2. Service Letter No.: SL29 66-12700

4. Part/Assembly No.: ECN 1161 Drawing 66-12700

5. Float Model Affected: 6650

Figure 1: Hydraulic Tube # 17 (9) with Union, Flared Tube (40)

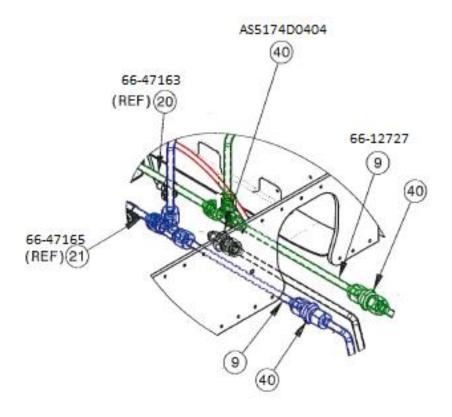
1. 66-12700: Add 66-12727 (2X) (Figure 1) and AS5174D0404 Unions (Figures 1 and 2) (2X) to RHS hydraulics exit.

2. 66-12727: New

Figure 2: Longer Hydraulic Tubes (20 and 21)

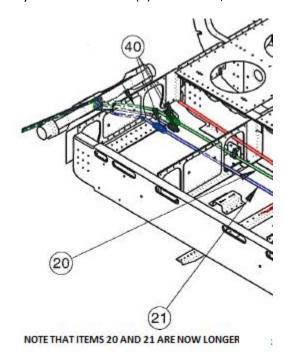
66-47163: Length 36.00 was 33.63.
66-47165: Length 36.00 was 32.75

5. Verify length and/or replace existing 66-47163 and 66-47165 tube assemblies with Rev A, longer versions when changing 66-12731 flexible hose assemblies. (Ref Service Letter SL66-12700. Add 66-12727.
